Public Comment Opportunity

Mill River Sediment Remedial Action Plan, Draft NPDES Permit and Application to OLI & General Permit

Subject: Conservation staff review of Exide's proposed remedial action plan for lead-contaminated sediments in Mill River and Southport Harbor (SedRAP, April 2012)

Date: December 28, 2012

Photo #1

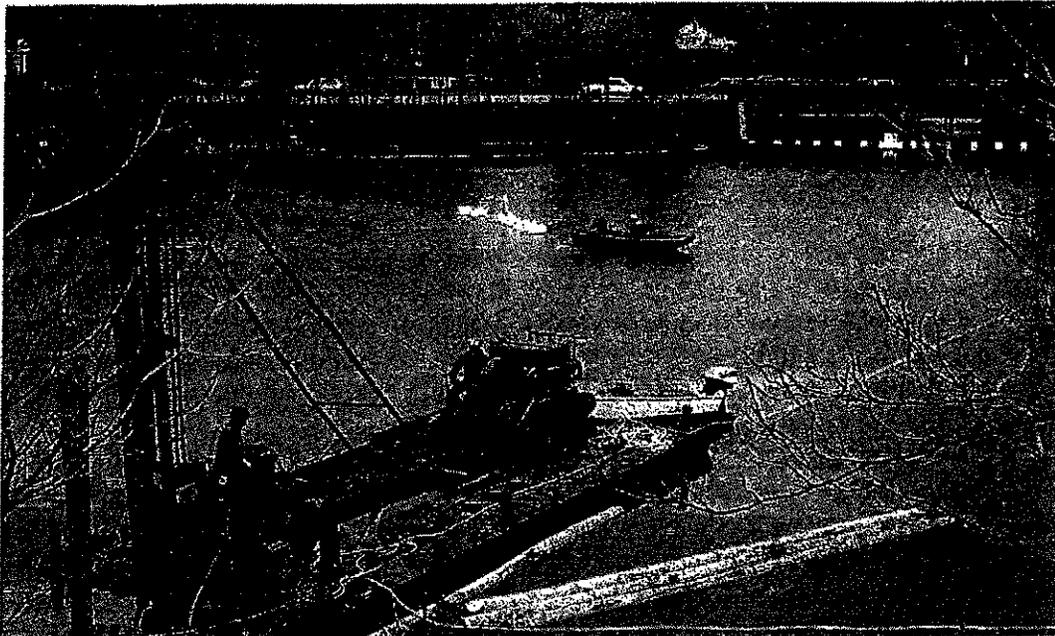
View of Exide's 1983 Mill River sediment Lead remediation project. The work barge in the foreground is driving timber piling along the shoreline to support the cable for shifting the dredge as it cuts into the river bottom. '83 tjs

Photo #2

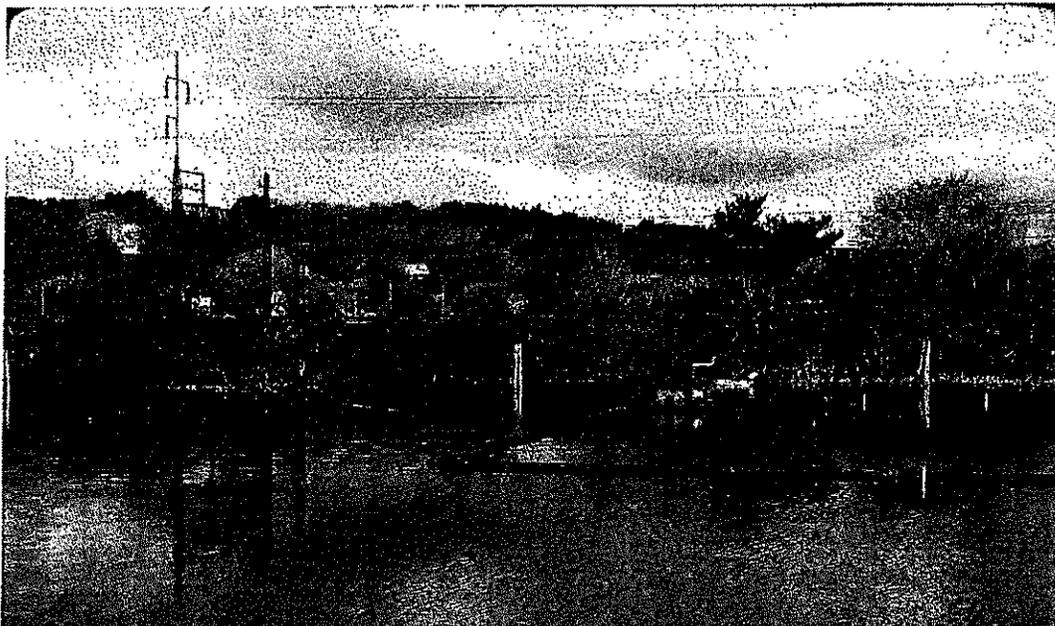
Looking northerly at Exide's 1983 Lead remediation project in Mill River sediments. The floating silt curtain is deployed around the dredge cell on the left side to protect the open water in the river; the pile-driver is installing timber support piles for shifting the dredge on cables; the hydraulic cutterhead dredge is dredging the bottom sediment and pumping it through a floating pipeline to the treatment and disposal area. April 1983 tjs

Photo #5

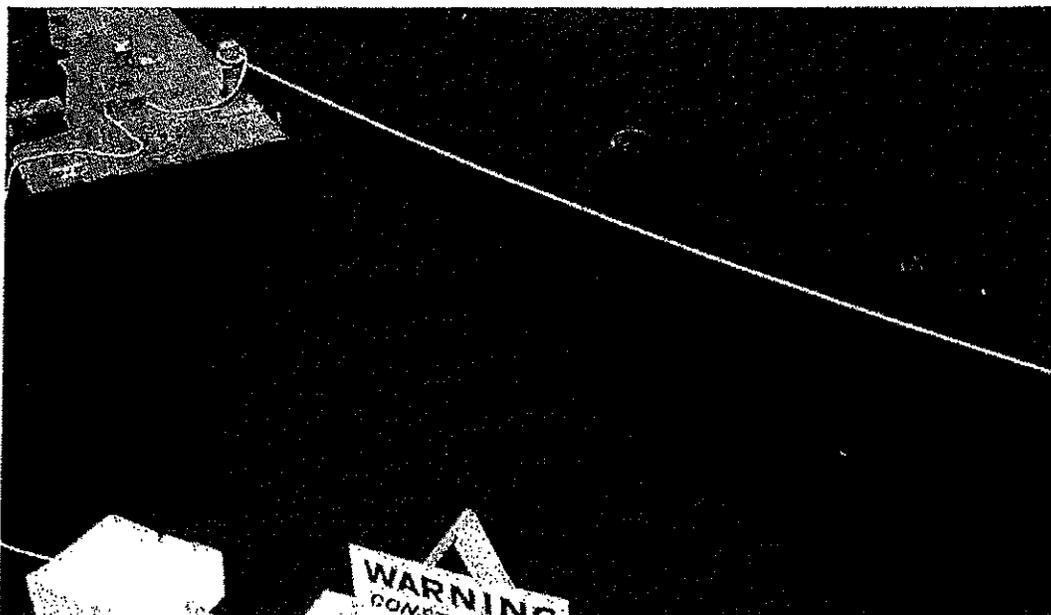
View of Exide's 1983 Lead remediation of Mill River sediments. The silt curtain to upper right is intended to separate the resuspended sediment within the active dredge cell from the protected open water in the river located to the left. Note the boiling clouds of resuspended sediment blowing out from beneath the curtain into the open river water between the rope and the warning sign. April 1983 tjs
